**Palisades Nuclear Plant**

NUCLEAR MANAGEMENT COMPANY, LLC
PALISADES NUCLEAR PLANT, DOCKET 50-255, LICENSE DPR-20
REQUEST FOR CHANGE TO PALISADES PLANT TECHNICAL SPECIFICATION
MAXIMUM ALLOWED VALUE FOR VARIABLE HIGH POWER TRIP

**TECHNICAL SPECIFICATION CHANGE REQUEST
ALLOWED VALUE FOR VARIABLE HIGH POWER TRIP**

**LICENSE AMENDMENT REQUEST PURSUANT TO 10 CFR 50.90:
TECHNICAL SPECIFICATION MAXIMUM ALLOWED VALUE FOR
VARIABLE HIGH POWER TRIP**

**FIGURE 1:
Proposed VHP Trip Calculated Setpoint, and New Technical Specification Allowable Value**

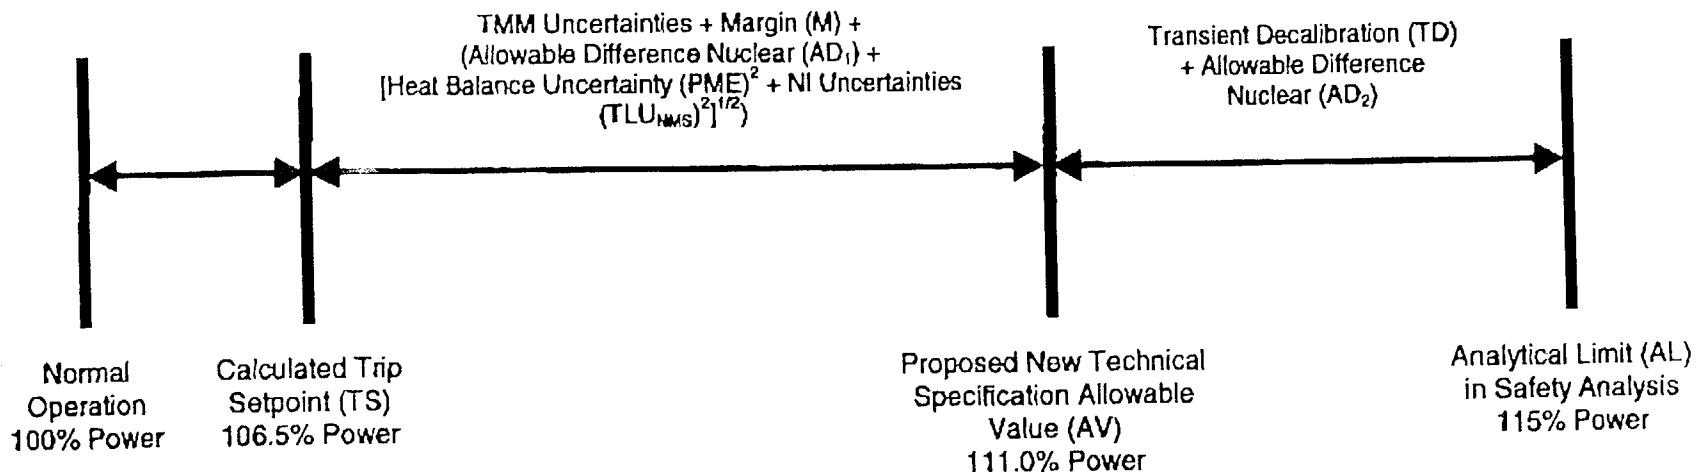
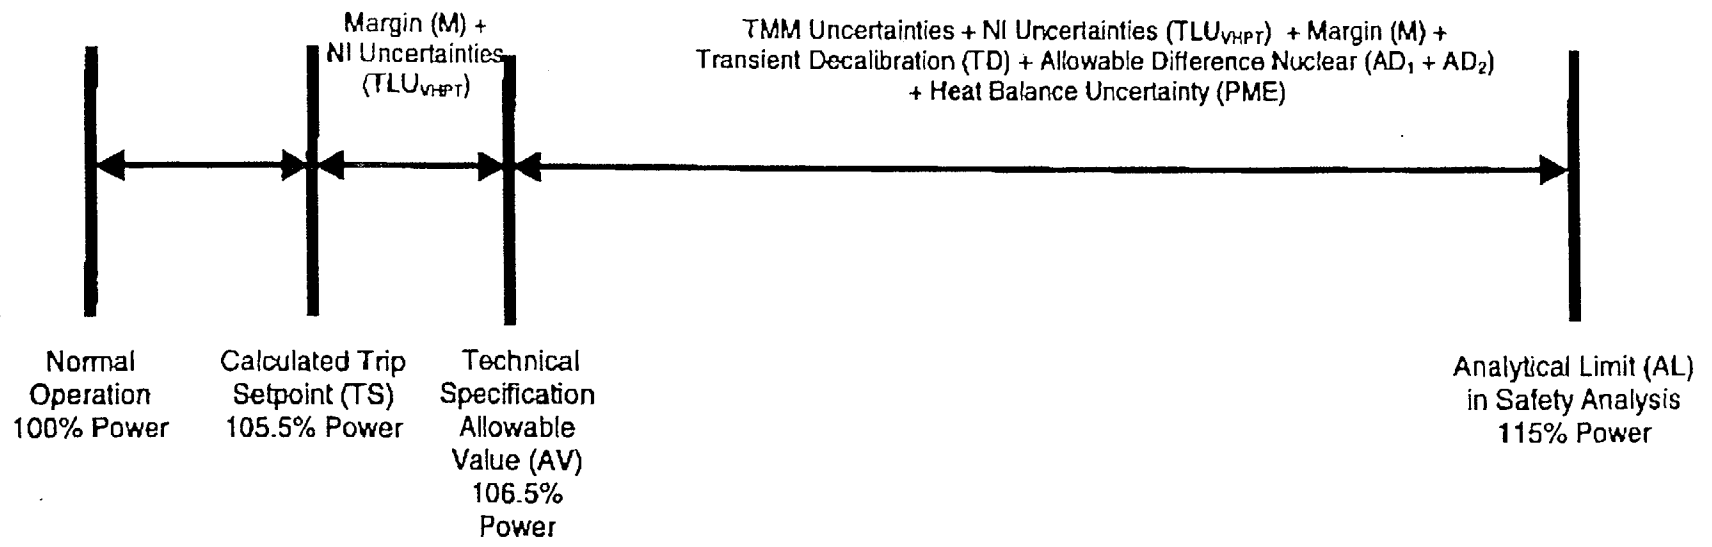
See Figure 1 for a visual representation describing how the different uncertainty terms were applied in determining the VHPT allowable value and the calculated trip setpoint. Figure 2 is included for comparison purposes. It describes the current application of uncertainty terms for the AV, TS and AL and shows how the NI Uncertainties are accounted for twice.

$$\begin{aligned} \text{VHP Trip Setpoint, TS} &= \text{AL} - (\text{AD}_2 + \text{TD}) - (\text{AD}_1 + [\text{PME}^2 + \text{TLU}_{\text{NMS}}^2]^{1/2}) - \text{M} \\ &= 115\% - (1.0\% + 3.0\%) - (2.0\% + [2.0\%^2 + 0.5\%^2]^{1/2}) \\ &\quad - 0.44\% \\ &= 106.5\% \end{aligned}$$

$$\begin{aligned} \text{New VHP Trip Allowable Value, AV} &= \text{TS} + (\text{AD}_1 + [\text{PME}^2 + \text{TLU}_{\text{NMS}}^2]^{1/2}) + \text{M} \\ &= 106.5\% + (2.0\% + [2.0\%^2 + 0.5\%^2]^{1/2}) \\ &\quad + 0.44\% \\ &= 111.0\% \end{aligned}$$
